# Access Compliance Report

## Public Rights-of-Way

### (Curb Ramps)

Intersection ID: 25357	Main Street: RAINTREE_LN	Cross Street: WILLOW_POINT_DR	Location: SE
ADA ID: 6651F5229161	Ramp Type: PerpDiag	Initial Pass/Fail: Fail	Overall Compliance: No
		Severity Score: 12.5

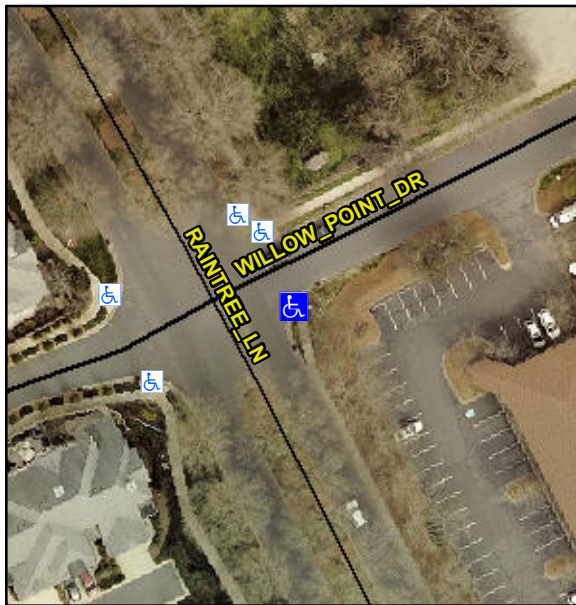
**Not Found, R304.2.2**

Compliance	Description	Data	Compliance	Description	Data
N/A	Ramp Length (in)	68.0	No	Ramp Slope (%)	9.0
Yes	Ramp Width (in)	54.0	Yes	Ramp XSlope (%)	0.5
N/A	Flare Type LT	N/A	N/A	Flare Type RT	N/A
N/A	Flare Slope LT (%)	N/A	N/A	Flare Slope RT (%)	N/A
N/A	Flare Traversable LT?	N/A	N/A	Flare Traversable RT?	N/A
N/A	Landing Length (in)	N/A	N/A	DWS Provided?	N/A
N/A	Landing Width (in)	N/A	N/A	DWS Contrast?	N/A
N/A	Landing Slope (%)	N/A	N/A	DWS Length (in)	N/A
N/A	Landing X Slope (%)	N/A	N/A	DWS Full Width?	N/A
N/A	Landing Curb? (Y/N)	N/A	N/A	DWS Offset (in)	N/A
N/A	Shared Landing?	N/A			
N/A	Gutter Ponding?	N/A	N/A	Gutter Slope (%)	N/A
N/A	Gutter Lip Ht (in)	N/A	N/A	Gutter X Slope (%)	N/A
N/A	Painted X Walk1?	No	N/A	Painted X Walk2?	No
	X Walk 1 Direction	To NW		X Walk 2 Direction	To SW
N/A	X Walk 1 Width (in)	N/A	N/A	X Walk 2 Width (in)	N/A
	X Walk 1 Slope (%)	2.3		X Walk 2 Slope (%)	1.5
	X Walk 1 X Slope (%)	3.8		X Walk 2 X Slope (%)	0.1

**Remove & Replace Curb Ramp With Two New Directional Ramps or Equivalent.**
